OREGON STATE UNIVERSITY (OSU)

DRYDEN HALL

ADA ASSESSMENT & SURVEY

Re: ADA Accessibility Survey and Assessment – Dryden Hall

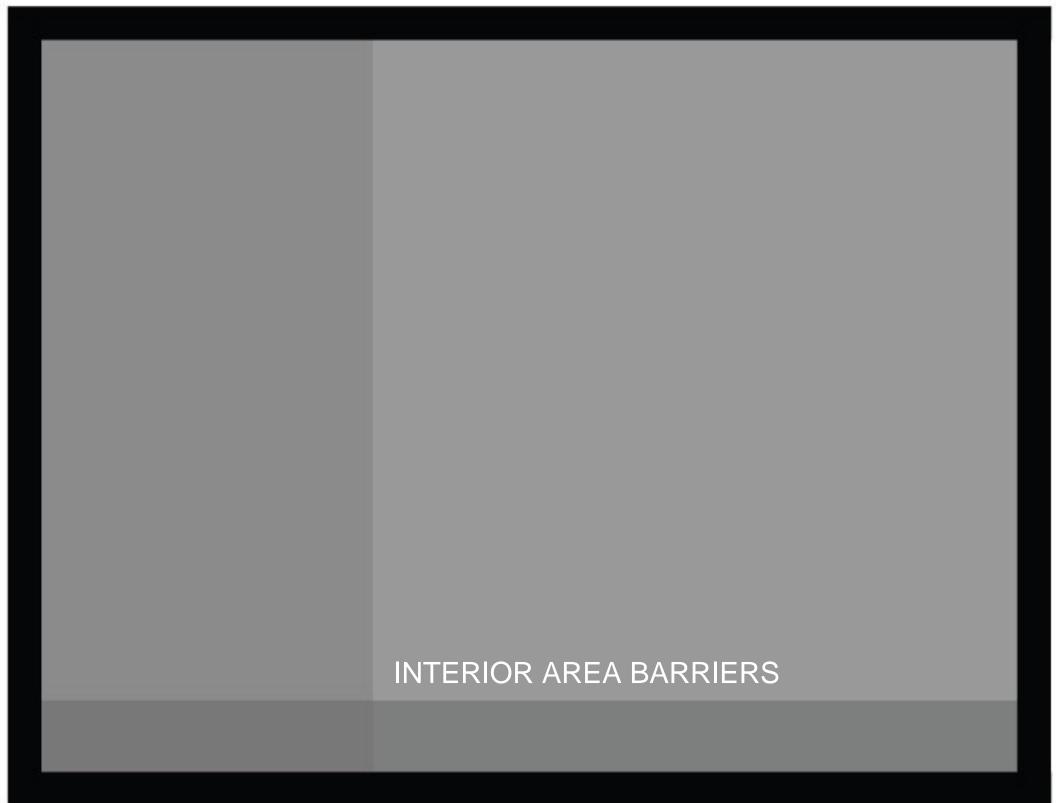
Barrier Type: Code References: Performance Sta Barrier Description: Findings: Rec. Solution:	Stairways Contrasting Color - ADA 2010 ADAS Advisory 504.4 ndard: Yes Quantity: LF or TR As-built: 35 No contrasting color on each tread of exterior stairway No contrasting color provided Consider providing contrasting color on each tread 2 Recommended Cost Est \$0.00 Facility Function: Public Status: Open
